ASSESSMENT REPORT

Section 75W Modification Rainbow Beach Estate Concept Plan (MP 06_0085 MOD 1)

Figure 3: Proposed modification to the concept plan

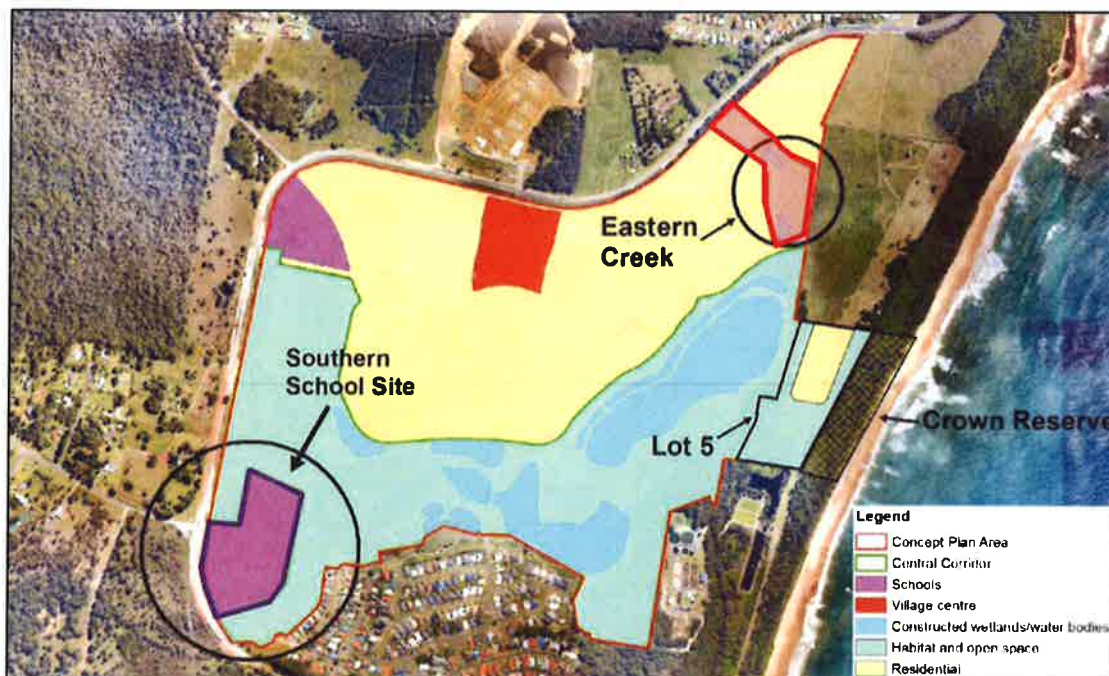
The proposed modification would increase the overall residential land across the site (north of the Eastern Creek area and surrounding Lot 5), by 9,330 m², and increase overall environmental management land across the site by 7,130 m². These increases result in a decrease to the area of the Southern School Site. These changes are outlined within **Table 1**.

The modification request seeks to amend the boundaries of environmental land at three locations across the site (see **Figure 3**); Eastern Creek, Lot 5 and around the Southern School Site.

Figure 4: Approved Eastern Creek Area

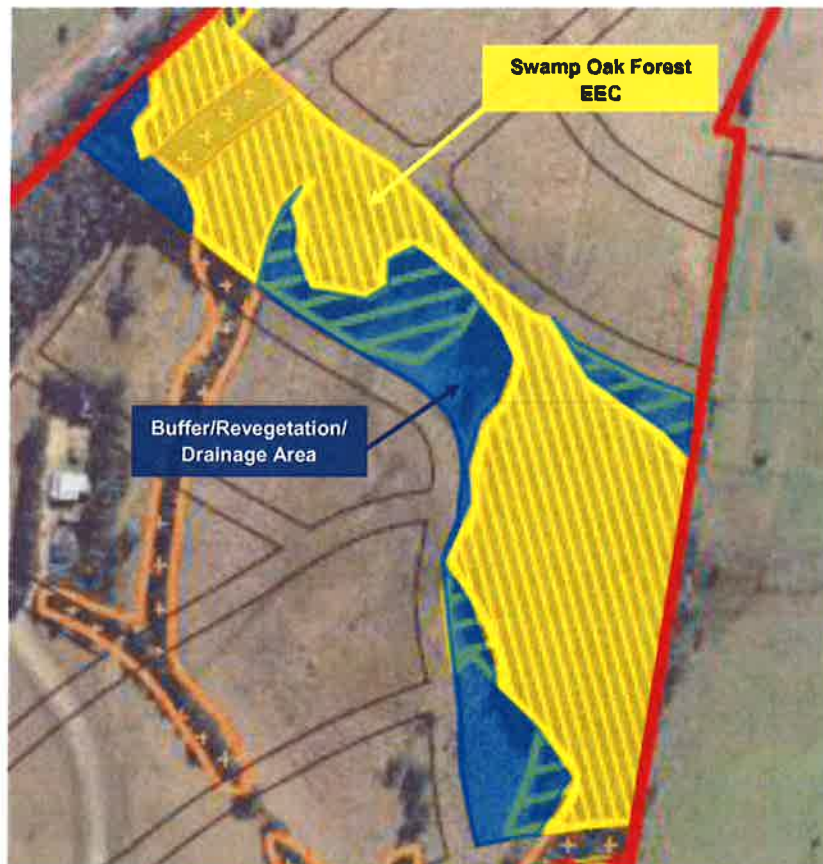
The modification request seeks to amend the boundary of the Swamp Oak Forest EEC within the Eastern Creek area to more accurately reflect the extent of the Swamp Oak Forest EEC. The Proponent has requested that the extent of this EEC be revised to take into consideration updated soil information and the legal precedents that link the identification of an EEC to its associated soil and landscape criteria. The proposed changes to the Eastern Creek area are shown in the **Figure 5**.

The Proponent's assessment indicates the mapping provided as part of the Concept Plan application overestimated the extent of Swamp Oak Forest EEC. The mapping presented as part of the Concept Plan assessment:

- relied on broad mapping undertaken for other, more large scale projects; and
- did not adequately consider the soil landscape and flooding criteria presented within the NSW Scientific Committee's Final Determination for *Swamp oak floodplain forest of the NSW North Coast, Sydney Basin and South East Corner bioregions* (OEH 2011) (Final Determination).

As part of this modification request, the Proponent undertook ecological surveys and geotechnical investigations to compare the mapped area of Swamp Oak Forest EEC with the soil and landscape criteria presented within the Final Determination. These surveys indicated that whilst much of the vegetation in the Eastern Creek area matched the Final Determination, only the vegetation on areas of alluvial soils up to the 1:100 ARI comprise the EEC. The Proponent has based this conclusion upon the interpretation of the Final Determination provided by legal standards that link the identification of an EEC to its associated soil and landscape criteria. The legal precedent includes consideration of the soil type and landform patterns, in addition to the vegetation assemblage.

The Department assessed the Proponent's request in consultation with OEH. OEH were supportive of the requested modifications and considered them to be adequately justified. The Department supports the position of OEH and considers the request to modify the boundary of the EEC (taking into account the vegetation assemblage, soils and landform) to be justified in this instance. In supporting the request, the Department notes that a 25 metre (m) buffer area that formed part of the original approval would remain between the Swamp Oak Forest EEC and the residential areas. Further, the area of environmental management land that is to be modified to residential land is presently un-vegetated, which would require no further clearing.

Accordingly, the Department supports the more accurate delineation of Swamp Oak Forest EEC within the Eastern Creek area and has subsequently recommended modifications to the terms of the Concept Plan.

Figure 7: Proposed modifications to Lot 5

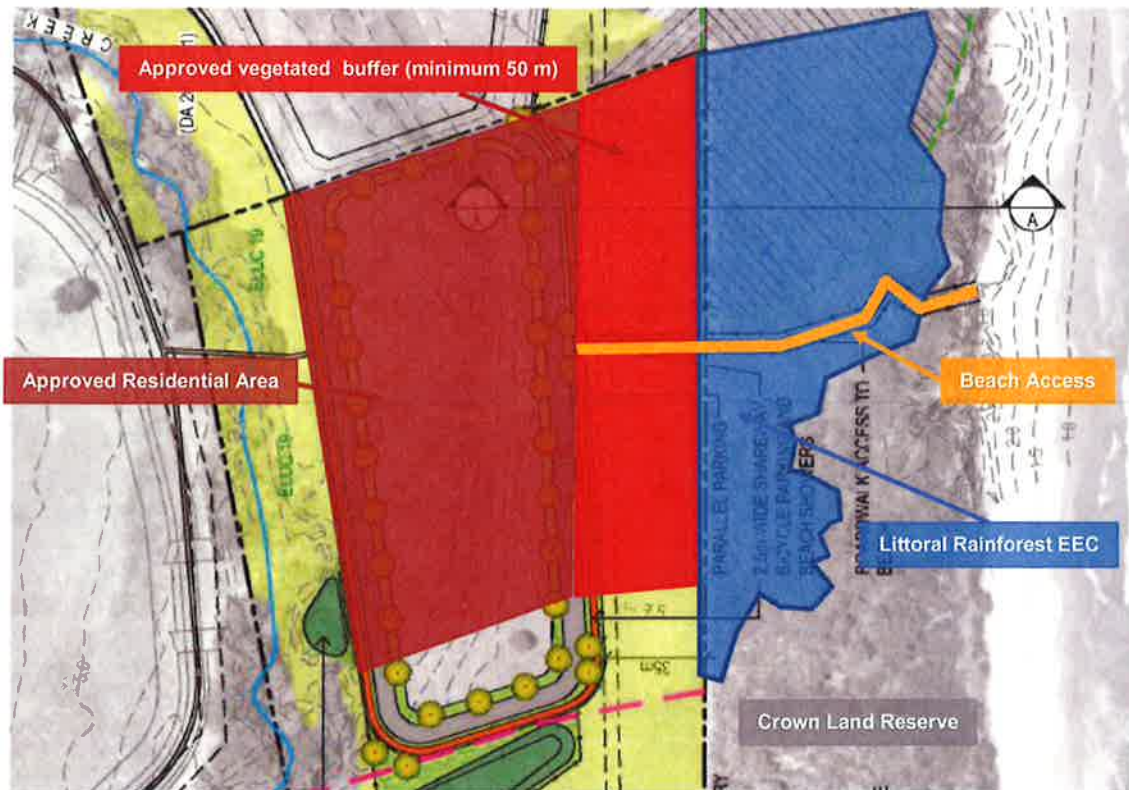
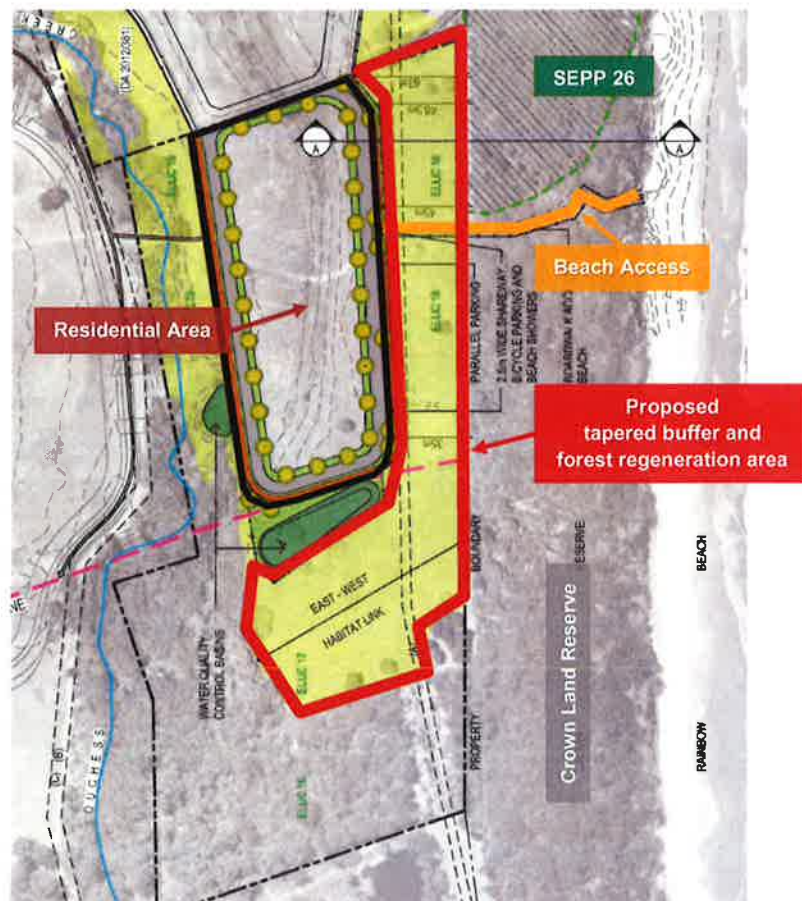
Lot 5 occurs in the eastern section of the site (see **Figure 2**). Under the approved Concept Plan, Lot 5 comprises a residential area, vegetated buffer areas (of minimum 50 m to the Crown Land Reserve) and an access path to the beach (see **Figure 6**). The Concept Plan requires a fully vegetated buffer of 50 m between the residential area and the Crown Land Reserve (see **Figure 6**). An area of *State Environmental Planning Policy 26 Littoral Rainforest* (SEPP 26) occurs in the Crown Land Reserve, immediately east of Lot 5. Patches of the EEC Littoral Rainforest and Coastal Vine Thickets of Eastern Australia (Littoral Rainforest EEC) also occur in the Crown Land Reserve.

The Proponent is requesting to modify the vegetated buffer to increase the residential yield in the area, whilst maintaining the environmental management buffer of the adjoining ecological assets. The modification request seeks to provide a buffer of 50 m to the north of the Lot, tapering to 35 m at the southern extent. To compensate for this realignment, the Proponent has proposed to assist regeneration of an additional 1.5 ha of land to the south and west of the buffer (see **Figure 7**). The Proponent's assessment indicates that the proposed modified buffer is unlikely to alter the ecological value of the vegetated buffer as approved in terms of the corridor effectiveness, habitat provision, edge effects and/or carrying capacity.

The Department has considered the realignment of the buffer area in consultation with OEH. The increase in the area of re-vegetation overall is supported and it is considered that the changes to the ecological value of the buffer are negligible. The Department's assessment has concluded that the realigned buffer area would result in similar corridor effectiveness and potentially increased habitat through improved connectivity with the increase in area to the south and west. As such, the Department supports this modification to the Concept Plan and has recommended modifications to the Concept Plan.

Figure 8: Eastern Chestnut Mouse Capture Sites and Proposed Regeneration and Buffer Areas

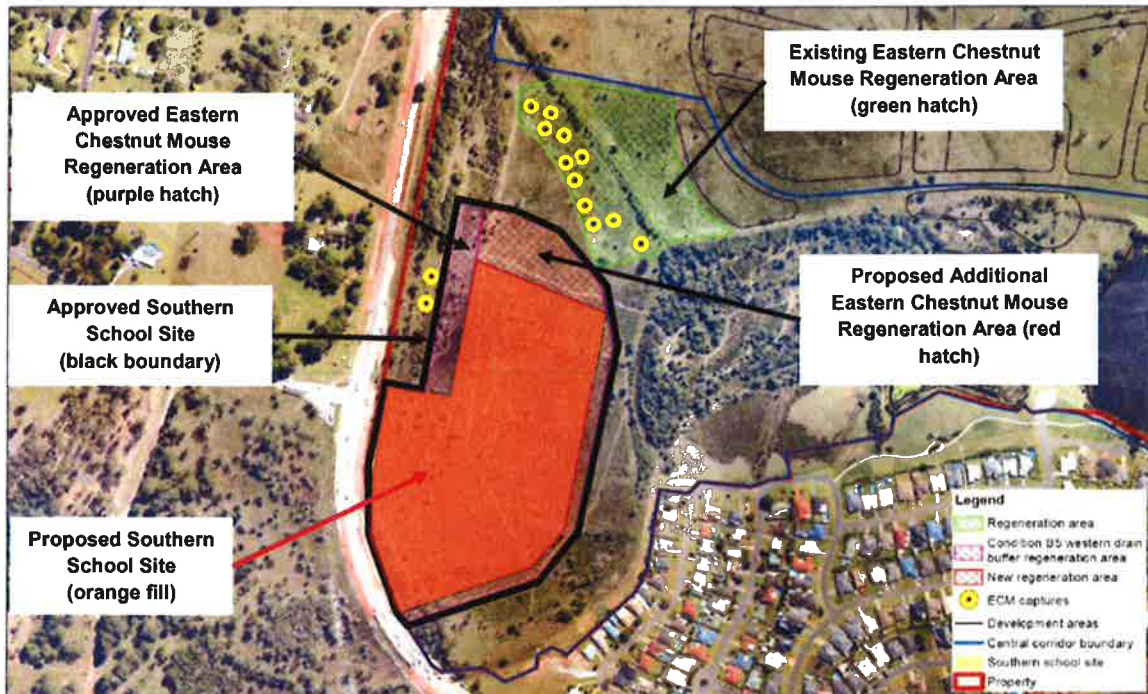
The Proponent is seeking a modification to rehabilitate the vegetation buffer around Lot 5 to fully structured Coastal Sands Blackbutt forest and remove the requirement to manage the area for the Eastern Chestnut Mouse (see **Figure 8**). This approach would provide a more effective habitat linkage with the surrounds and provide habitat for a larger range of local native species. In addition, the Proponent proposes to increase habitat for the Eastern Chestnut Mouse at the Southern School Site, where recent field studies have indicated a population of the species currently occurs (see **Section 7.1.3**).

The Southern School Site is located in the south-western portion of the site and comprises an area of 89,760 m² (see **Figure 2**). The approved Concept Plan requires the ongoing management of the area for the Eastern Chestnut Mouse and the inclusion of an adjacent buffer area, to ensure habitat availability is appropriately conserved and enhanced (see **Figure 8**).

Recent field studies undertaken by the Proponent have indicated that the area surrounding the Southern School Site continues to be suitable habitat for the Eastern Chestnut Mouse. Surveys undertaken in 2012 recorded the Eastern Chestnut Mouse in increased numbers to the west and north of the Southern School Site.

Based on the results of field studies, the Proponent has indicated that by increasing habitat for the Eastern Chestnut Mouse, there would likely be an increase in the Eastern Chestnut Mouse population.

The modification proposes to increase the environmental management land by 16,640 m². This would result in a correlating decrease in the size of the Southern School Site (see **Table 1**). This area would be integrated into the Central Corridor (see **Figure 3**) and managed as open space, drainage and wildlife habitat, as required by the Concept Plan as approved.

The Department considered the requested modification in consultation with OEH. OEH generally supported the request, however advised that fencing and bush regeneration should be implemented in accordance with a vegetation management plan. In response to matters raised by OEH, the Department notes that the Proponent's Statement of Commitments includes the preparation of a vegetation management plan during the development application stage. Further, the Department notes that the Proponent has entered into a VPA with respect to managing the environmental land within the Central Corridor for a period of 20 years, prior to handing over the land to Council (see **Section 6.1**). The modified area would be incorporated into the Central Corridor and subject to this agreement.

The Department has assessed the proposed changes and supports the proposed modification as it would result in an increase to the habitat area for the Eastern Chestnut Mouse, potentially resulting in an increase in the population of this species at the site. In addition, the Department agrees with the OEH and supports the increase in environmental management land at the site and the overall improved ecological outcome.

Figure 9: Crown Land Reserve VMP Area

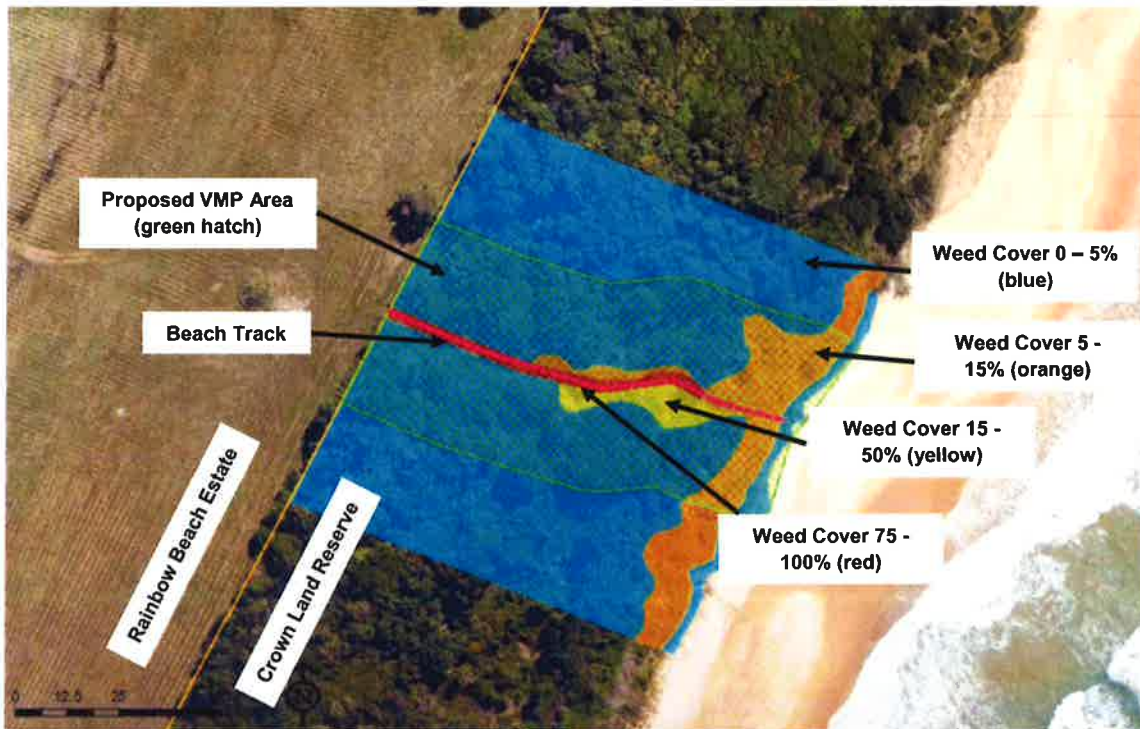
As the Concept Plan does not delineate the extent to which the VMP applies, the Proponent is seeking a modification to the Concept Plan to delineate the area to which the VMP apply. The Proponent has requested that the VMP apply to the area presented within **Figure 9**. This area includes vegetation 25 m to the north and south of the beach access path in addition to a 10 m wide strip along the length of the Crown Reserve along the interface with the site.

The Proponent has identified the area immediately adjacent to the access track as having the highest level of weed infestation in the Crown Land Reserve. As such, this area is likely to require ongoing management, particularly given the presence of the beach access pathway and potential edge effects. The Proponent also indicated that areas beyond the 25 m buffer have previously undergone significant bush regeneration works and are currently subject to ongoing management by Landcare. These areas were considered by the Proponent to be in good condition and are unlikely to be susceptible to invasion of weeds.

The Department assessed the proposed modifications and considered matters raised by agencies. The Department notes that the Department of Industry (Lands) did not provide comments regarding the proposed modification request and Council advised it supported the proposed limits to the extent of VMP which would provide additional certainty to both Council and the Proponent.

The Department has concluded that the proposed modification is acceptable and supports the requested delineation of the VMP area, as the vegetation outside of this area within the Crown Land reserve is in good condition and is not likely to require ongoing management. Accordingly, the Department has recommended modifications to the terms of the Concept Plan.
